This Service Information bulletin supersedes S.I. B51 02 05 **dated December 2006.**

Squeaking Noise From Door Frame Area While Driving

E60, E61 (5 Series)

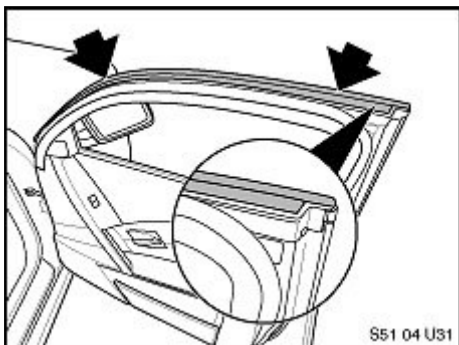
Movement between the flocking material (felt-like material indicated by the arrows) on the upper door seal and the surrounding roof panel may produce squeaking or creaking noises. These noises may be amplified by contamination or cleaner residue on the door opening.

In case of a customer complaint, refer to the procedure outlined below to replace the seals with improved parts and/or apply the specified transparent Teflon tape.

The flocking material was changed in 01/2005 to an improved material with exceptional rigidity, strength, and low moisture absorption.

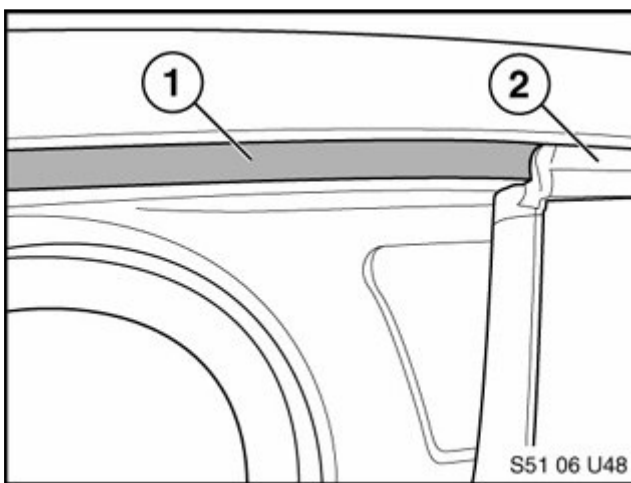
Apply a continuous length of Teflon tape

(PN 9 407 798) to the contact area of the flocking material (1) on the body of the vehicle.

The area where the tape should be applied to spans from the middle of the a-pillar to the rear-most point on the rear door opening as indicated by the arrows.

The tape should be applied slowly and very carefully to avoid trapping air bubbles under the tape.

To eliminate visibility of the tape when the door is closed and ensure proper contact with the flocking surface, the upper edge of the tape (1) should line up evenly with the top of the door seal (2) for the entire length of the applied area.

The tape should be applied in its full width (16mm), not be cut down to a narrower width.
